IEEE 802.11 Wireless Access Method and Physical Specification

Proposed Revision to 94/068

Section 4: FHSS PMD Sublayer

FIGURE 4.6: Data Jitter Tolerance

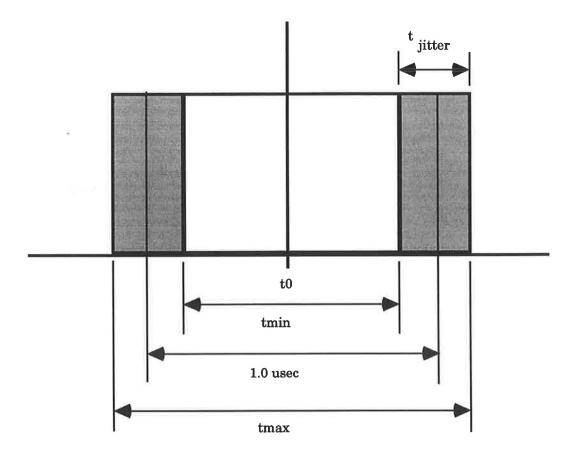
4.9.7 Receiver Data Jitter Tolerance (OPEN) A conformant PMD implementation must be capable of providing to the PLCP the following bit width restrictions as applied to a single logical "one" or logical "zero" data bit that meets the maximum run length and dc balance as specified in sections 4.9.x and 4.9.y. The jitter associated with each individual data bi, as referenced from the center of a nominal dat bit period of 1.0 microsecond is outlined in Figure 4.6.

Figure 4.7: Ramp-Up

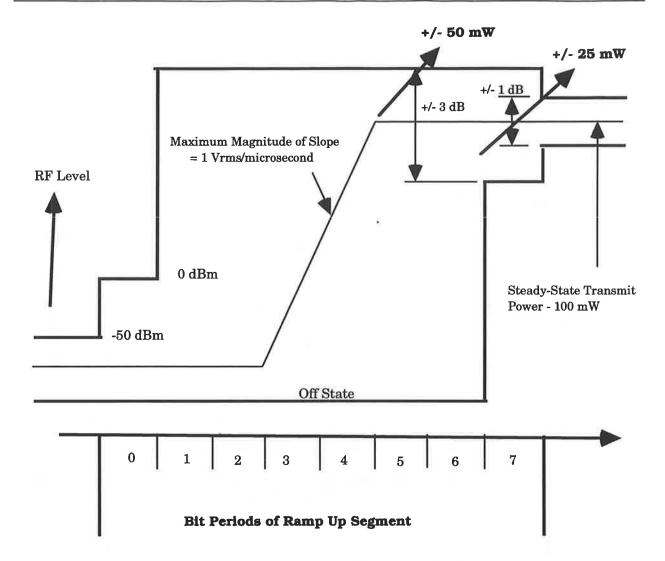
4.9.8.1 Ramp Up Period (CLOSED per A19) The purpose of a conformant PMD Ramp Up Time Period is to control the rate of change of the amplitude of the transmit signal durign its transition to the desired steady state transmit output level. The ramp-up period is defined as a window consisting of 8-bit periods and is governed by the mask of Figure 4.7.

The following states are defined by the mask of diagram Figure 4.7. The transmitter is considered "off" (i.e. less than -50 dBm EIRP) at the start of the first bit period and is less than 0 dBm at the end of the first bit period. The output level at the end of the seventh bit period is within 3 dB of the desired steady state transmit power level and within 1 dB at the end of the eighth bit period. The maximum magnitude of the rate of change of the output power level should be one volt per microsecond as measured by a wideband detector based on the RMS output voltage into a 50-ohm load of the conformant PMD.

Figure 4.8: Ramp-Down

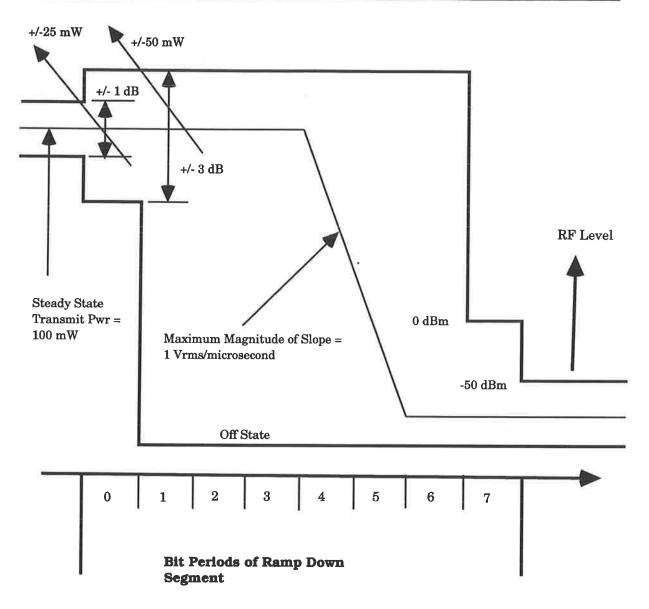
4.9.8.2 Ramp Down (CLOSED per A19) The purpose of a conformant PMD Ramp Down Time Period is to control the rate of change of the amplitude of the transmit signal durign its transition to the desired steady state transmit output level. The ramp-down period is defined as a window consisting of 8-bit periods and is governed by the mask of Figure 4.8.

The following states are defined by the mask of Figure 4.8. The transmitter is considered "off" (i.e. less than -50 dBm EIRP) at the start of the first bit period and is less than 0 dBm at the end of the first bit period. The output level at the end of the seventh bit period is within 3 dB of the desired steady state transmit power level and within 1 dB at the end of the eighth bit period. The maximum magnitude of the rate of change of the output power level should be one volt per microsecond as measured by a wideband detector based on the RMS output voltage into a 50-ohm load of the conformant PMD.
